YAMAP0777US

DRIVING ARRANGEMENTS FOR ACTIVE MATRIX LCDS

This paper is filed in order to correct certain typographical errors in one drawing figure of the above-identified application. Entry of the present paper is respectfully requested.

Figure 18

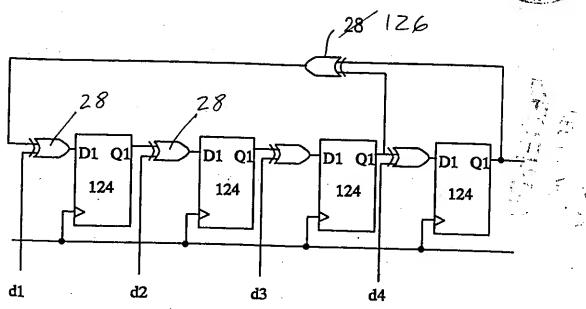
The presently submitted drawing sheet, Figure 18, contains proposed corrections of the reference numbers. The Figure 18 shown in the originally filed drawing sheet omitted and contained erroneous reference numbers, as a result of typographical errors. Applicants respectfully request entry of the corrected drawing sheet submitted herewith, and submit that such corrections do not constitute new matter.

The requested drawing changes are supported in the specification as filed. Figure 18 is similar to Figure 17, as indicated in the Brief Description of the Drawings at page 13 of the specification. Figure 18 includes the elements of Figure 17, and also includes the additional XOR logic gates 28, mentioned at page 13, lines 14-16 and described at page 26, lines 13-15. In the originally submitted Figure 18, these additional XOR logic gates 28 were not identified by reference numerals. In addition, in the originally submitted Figure 18, the XOR logic gate 126 shown in Figure 17 was erroneously identified by reference numeral 28.

Thus, the presently submitted proposed drawing corrections propose (a) to insert the reference numeral 28 to identify the additional XOR logic gates which were added to the embodiment shown in Figure 17 to provide the embodiment shown in Figure 18; and (b) to correct the reference numeral identification of the single XOR logic gate 126 from the erroneously applied reference numeral 28.
